TECHNICAL BULLETIN

16

Subject: Control Board Washers – 2000e Series
Applies to: All CBS-2000e Series Coffee Brewers

Date: May 19, 2004

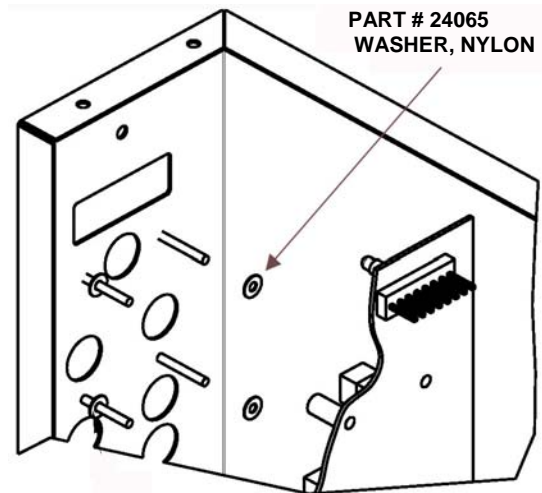
Due to variations in the front panels and control boards on 2000e Series coffee brewers, the control board may occasionally be positioned too close to the plastic overlay. This may cause excessive pressure on the buttons, causing them to stick and generating error code 255.

As a temporary solution to prevent this problem, Manufacturing has begun using small nylon washers as spacers on the posts to which the control boards are mounted.

The permanent solution is to lengthen the standoffs on the control boards. This will occur on the next production run of circuit boards in approximately one month. The nylon washers will then be discontinued on new equipment and replacement boards.

When installing a replacement control board with washers, place one washer on each mounting post as shown in the drawing. If the brewer already has washers on the posts, it is not necessary to install additional washers.
